Interoffice Memorandum

**Subject: Whirlwind Mine (Permit No. M-2007-044)  
TR-2**

As you requested, I reviewed the material submitted with the Whirlwind Mine TR-2 application. My focus was on aspects of the submittal concerning potential impacts to the hydrologic balance. I also reviewed documents from the currently approved permit file, and recently submitted hydrology reports.

*Figure 1: Process flow diagram, copied from Appendix H2*

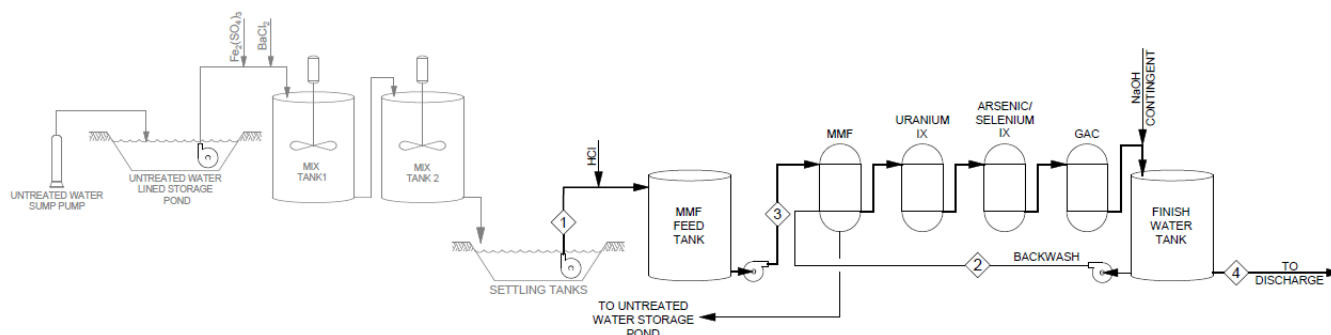
The proposed add-on system is thoroughly described in the material submitted with TR-2. In summary, the system takes treated water from the existing settling/polishing tanks, and passes it in series, through

sand filters (to remove suspended solids), a strong base anion exchange resin (to remove uranium), a second ion exchange resin (to remove arsenic and selenium), and activated carbon (to remove organic compounds). The effluent is treated with sodium hydroxide, as necessary, to raise the pH prior to discharge, see Figure 1.
